Heritage Impact Assessment
Manselton Primary School,
Manor Road, Manselton SA5 9PA

By Anva

Proposed Ground Floor Plan (Version 1)

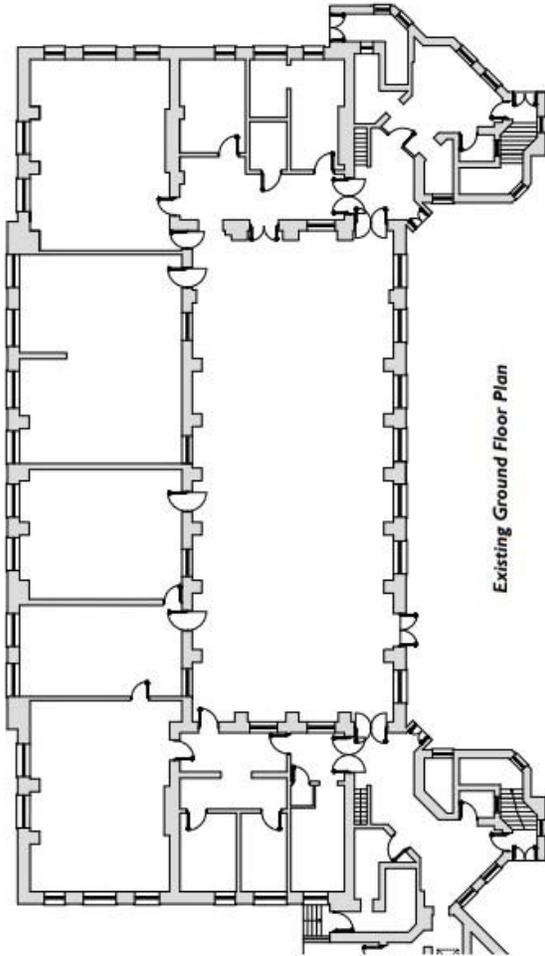
On the mark-ups, we have identified – in red – existing walls which are original (or more recent walls on the line of the original walls) which the proposals seek to remove. In green, we have identified the locations where the proposal is for new walls on the line of the original walls. We would ask whether it would be

possible to retain the existing walls, as long as they are deemed to meet the requisite fire and/or acoustic standard; and, if they do not, whether an extra skin of fireline board, on one or both faces, might allow for their retention.

We have also identified – in dotted boxes – areas where the existing fabric (which we believe to be original) is proposed for removal. Those boxes in red relate to fabric proposed for removal which we would suggest ideally would not be removed, as they are of considerable heritage significance. Those boxes in orange identify fabric which would ideally also not be removed, however, which we can understand the benefit of removal and can see some justification for its removal.

floor. This is good, and would be a beneficial variation to the proposals. This area has been identified on our mark-up of the ground floor in an orange dotted box. However, arguably, the top floor would be the more interesting space to remain open as, with its exposed timber and iron trusses and open roofspace, it is a more aesthetically interesting space.
